May 1, 2023
Addendum 1
66-02-02-03-0-001-032
66-02-02-03-0-002-029
66-02-02-03-0-003-033
66-02-02-03-1-010-007
66-02-02-03-5-004-008

Croton Harmon Union Free School District
District Wide Roofing Project

This Addendum consists of the following information:

ASK-01

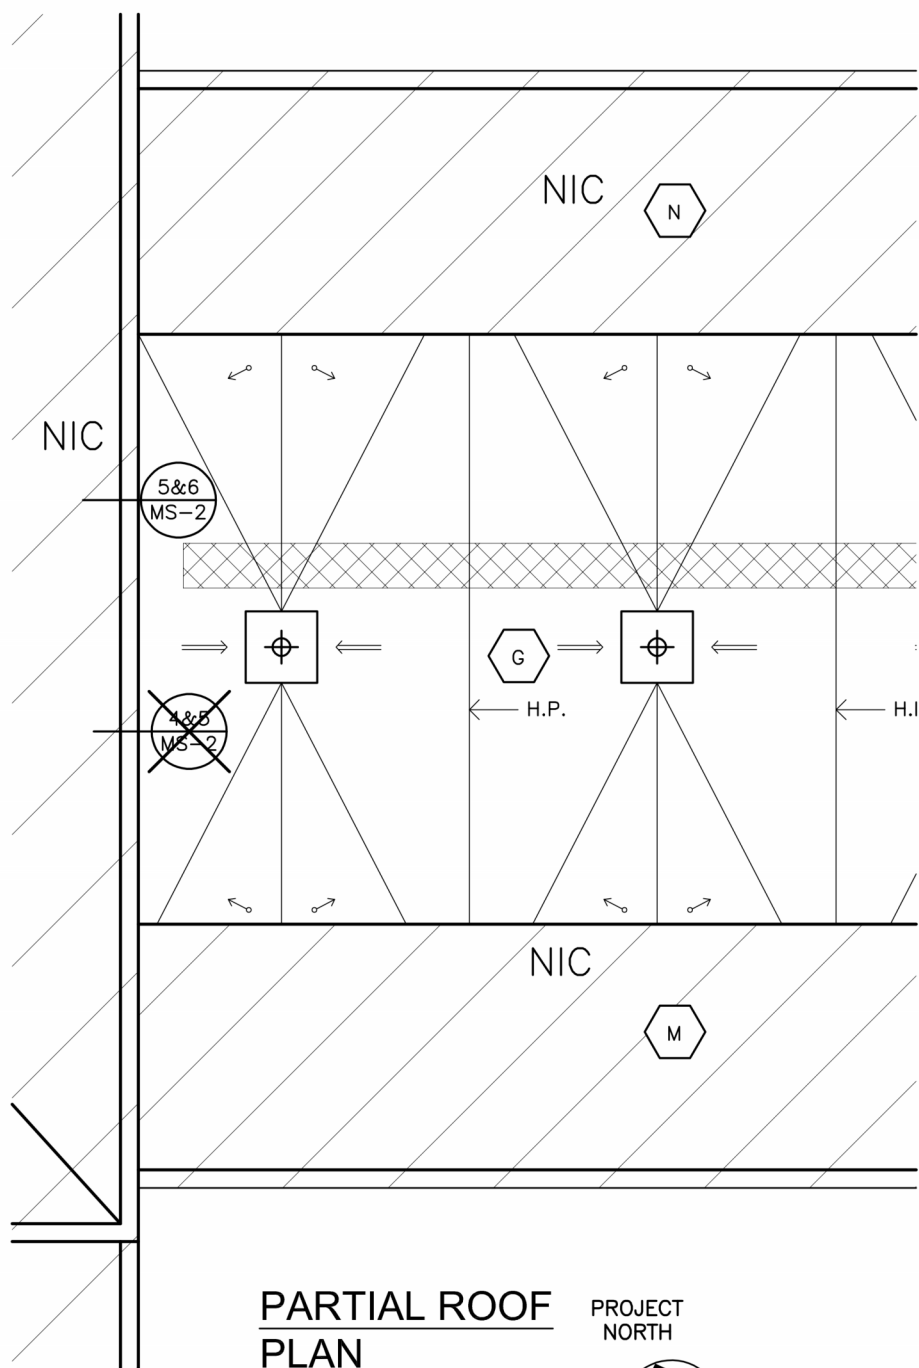
| 1. | See ASK-01 "Partial Roof Plan" for detail call out correction. |

ASK-02

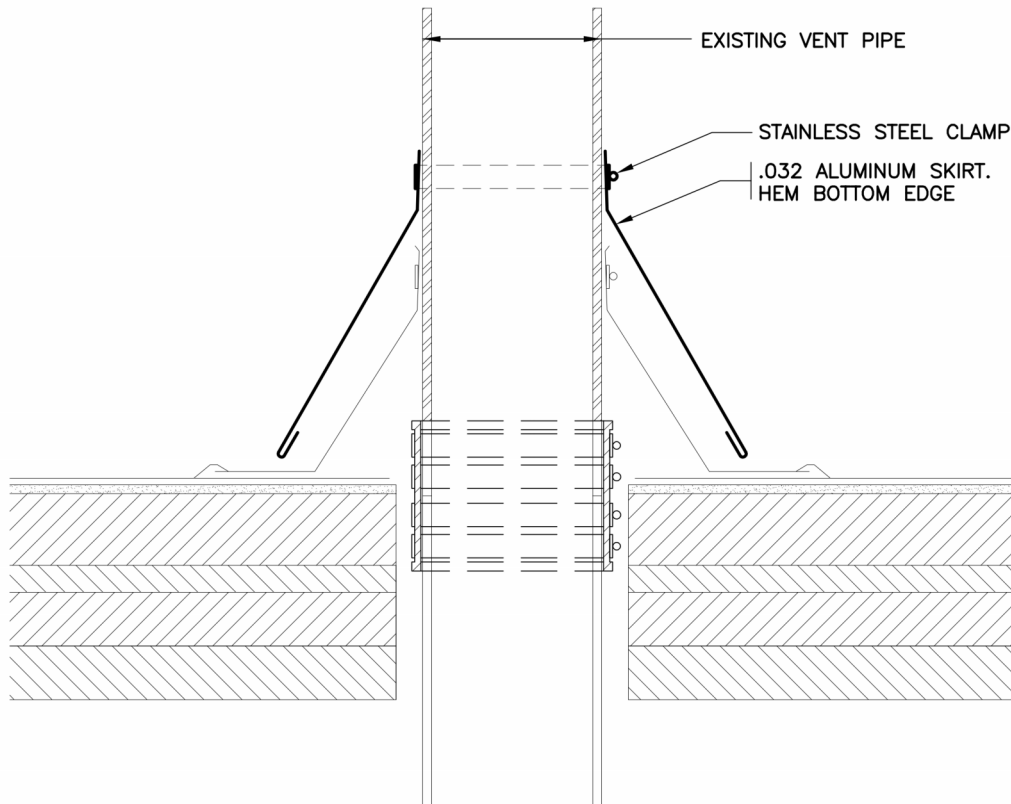
| 2. | See ASK-02 "Metal Pipe Skirt" for added aluminum pipe skirt for bird deterrence. |

CONTRACTOR TO PROVIDE (10) METAL PIPE SKIRTS- LOCATIONS TO BE DETERMINED IN THE FIELD- CONSULT WITH OWNER ON FINAL LOCATIONS- NOTE METAL PIPE SKIRTS ARE NOT INTENDED TO BE PART OF THE WATERPROOFING SYSTEM- PIPE SKIRTS ARE TO BE PART OF THE BIRD DETERRENT SYSTEM
